PG&E Letter DCL-03-077

Docket No. 50-275, OL-DPR-80  
Docket No. 50-323, OL-DPR-82  
Diablo Canyon Units 1 and 2  
Response to NRC Questions Regarding License Amendment Request 02-03,  
"Spent Fuel Cask Handling"

NRC Question 1

Figure 2-1 – Conceptual Vault Remediation

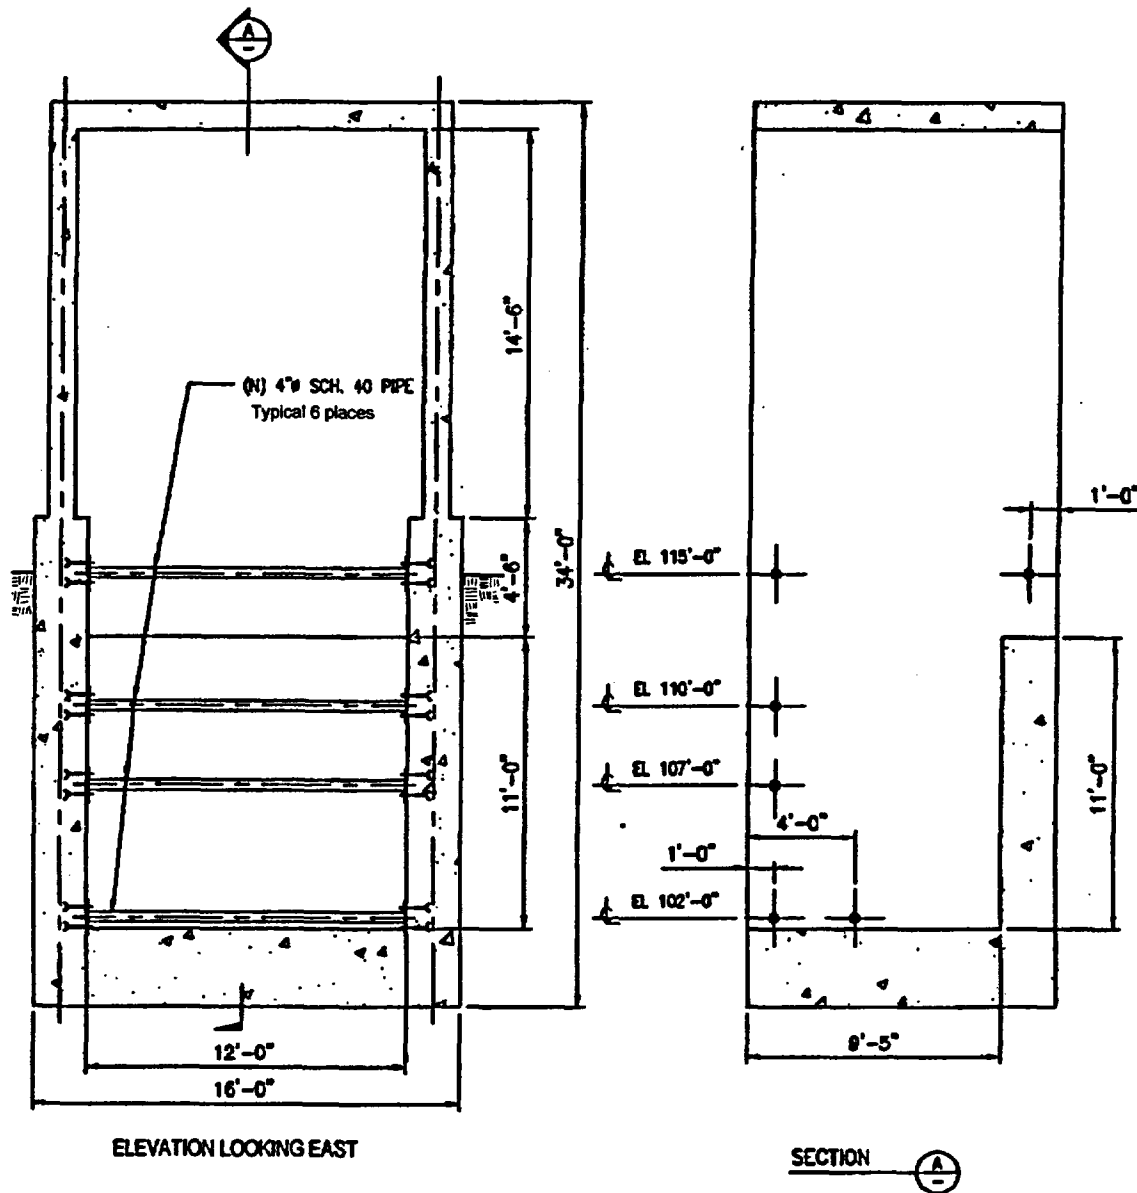
*You stated in page 16 of the Reference that "...Vital water tank piping vault ... Initial assessment indicates a need for more detailed evaluation and/or analyses ..." Provide the following:*

- a) What evaluation and/or analyses do you plan to perform?*
- b) Submit the results of the evaluation and/or analyses to the NRC for review.*

- b) The results show that the vault walls are overstressed for the normal condition and for the abnormal condition that combines seismic and cask transporter surcharge loading. Capacity to demand ratios for the various loading conditions are tabulated in Table 2-1. The vault walls will be remediated prior to cask transport operations so that the walls meet the appropriate acceptance criteria. A conceptual remediation is shown in Figure 2-1. The remediation deploys shoring struts at selected elevations in the vault to support the vault walls. The wall flexure load is reduced by the distributed action of the axial forces in the struts to the opposing wall surface.

Figure 9-1

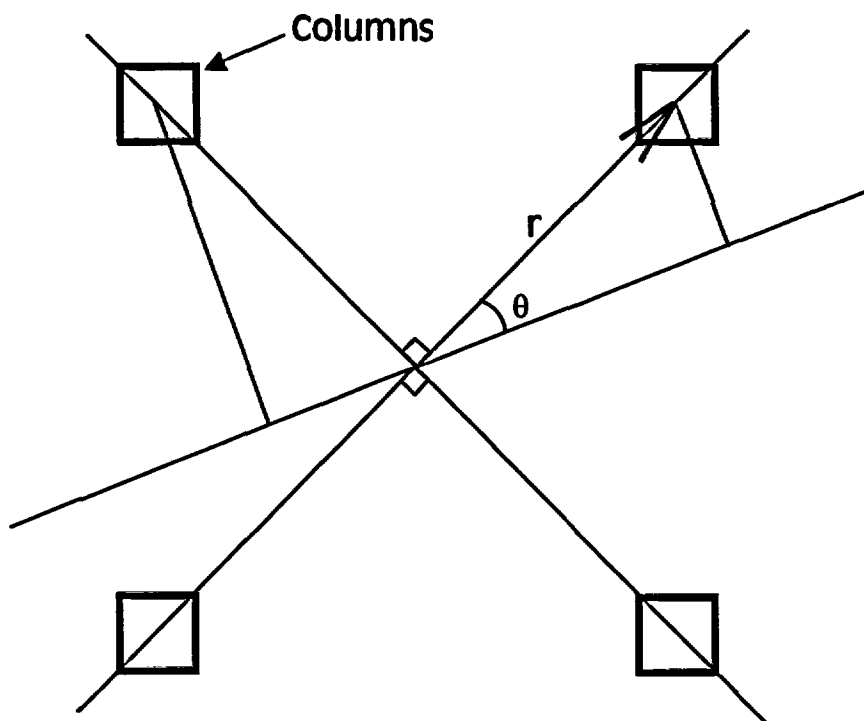
- b) Explanation and justification for consistency between the stiffness calculation of the structure in 2-D nonlinear dynamic analyses from the stiffness developed from the 3-D linear static analyses.*

The dynamic properties of the SFP Frame are dependant on the area moment of inertia, the distance between supports and support conditions, the modulus of elasticity and the mass density of the structure. If all these properties do not vary in one of the three spatial dimensions then the SFP Frame can be modeled by a two dimensional model. The modulus of elasticity and the mass density of the structure are uniform throughout.

The four columns of the structure are the significant contributors to the area moment of inertia (see Figure 9-1). As shown in Figure 9-1, the area moment of inertia of a regular frame structure such as the SFP Frame is not a function of the angle  $\theta$ . There is an opening on the east side of the frame that allows fuel to be loaded into the cask. The effect of this opening on the overall stiffness of the frame is minimal. Due to the SFP Frame's column connectivity, only small variations in the stiffness in the NS and EW directions at various elevations were found (PG&E Calculation 52.15.136).

Figure 9-3 – Cask Restraint at Elevation 111 ft 0 inches

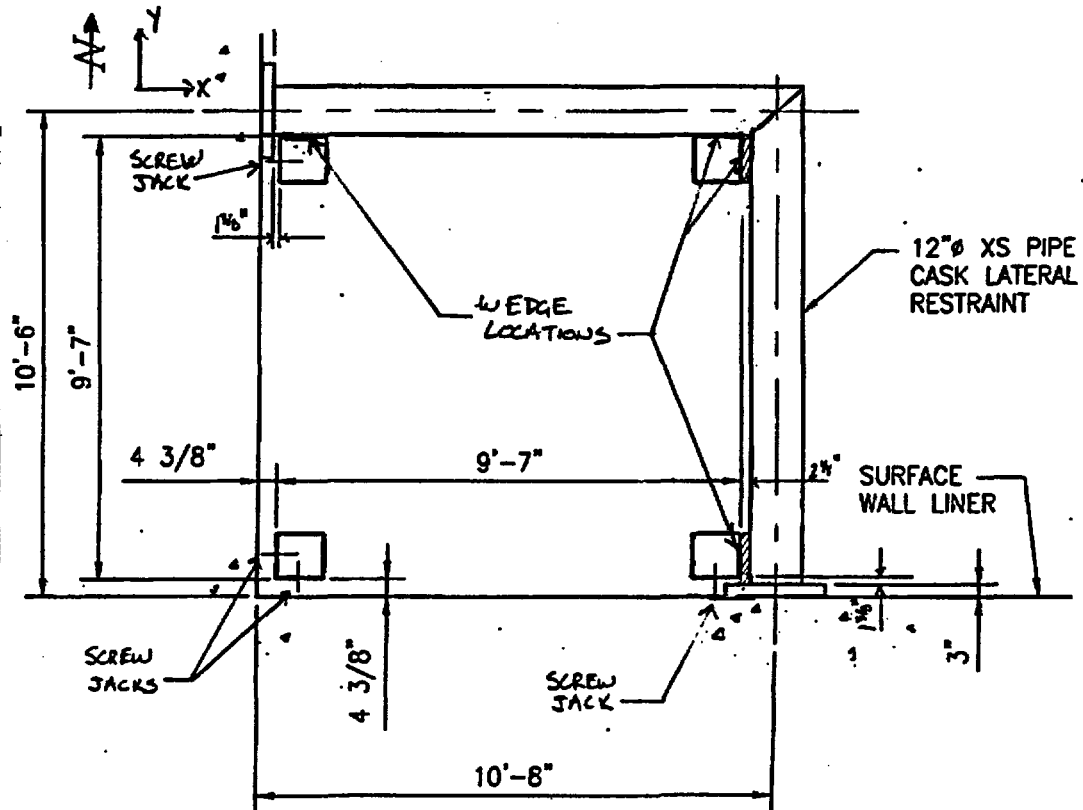
- d) The results of the 3-D static analyses for structural member sizing and support reactions with the structural acceptance criteria used.*
- e) Description of the restraint and the results of the analyses for the restraints on the SFP frame at Elevation 111 ft. and 140 ft.*

e) SFP Elevation 111 ft restraint:

The elevation 111 ft restraint frames around the cask recess area in the SFP. The restraining pipes, horizontal and vertical, are 12 inch $\phi$  Schedule XS Type 304 stainless steel. The support was analyzed and found to meet the acceptance criteria as described in Response 9d. A plan view of the support at elevation 111 ft is shown in Figure 9-3. The SFP frame column placement is shown also. The maximum reactions are shown in Table 9-2. It should be noted that screw jacks are located at the NW, SW, and SE frame columns at elevations 111 ft 0 inches and 94 ft 6 inches.

Figure 12-1 – Plan View of SFP Walls (Unit 1 shown)

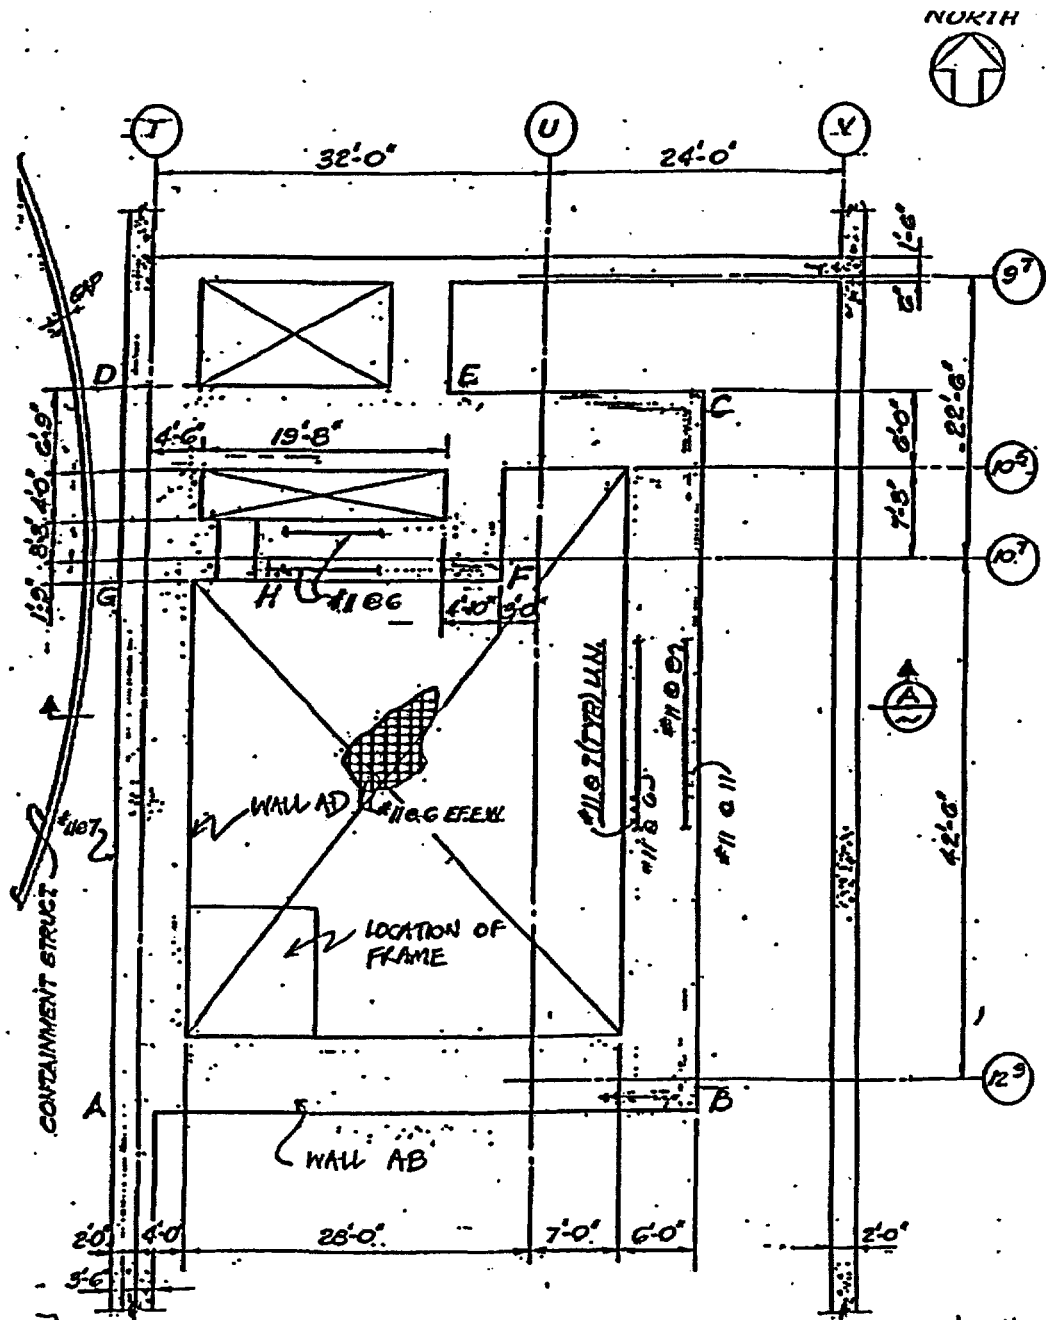
- a) *Provide the physical dimensions of the SFP including the thickness of the reinforced concrete (RC) slab and walls and liner plate.*
- b) *Provide a copy of the mesh used in the analysis.*
- c) *Describe the boundary conditions used.*
- d) *Describe the applied loading conditions including their magnitudes.*
- e) *Explain how the SSE loading was applied to the SFP. If you used equivalent static analysis, provide justification for this approximation. What were the magnitudes of the equivalent static accelerations applied at mass points you used in the analysis?*

- a) The SFP is a Design Class I, safety-related reinforced concrete structure. The pool walls and base-mat provide containment for the borated water within the SFP. A plan view of the pool at elevation 140 ft is shown in Figure 12-1. The walls of interest are labeled Wall AB & AD (on grid lines 12<sup>9</sup> and T, respectively).
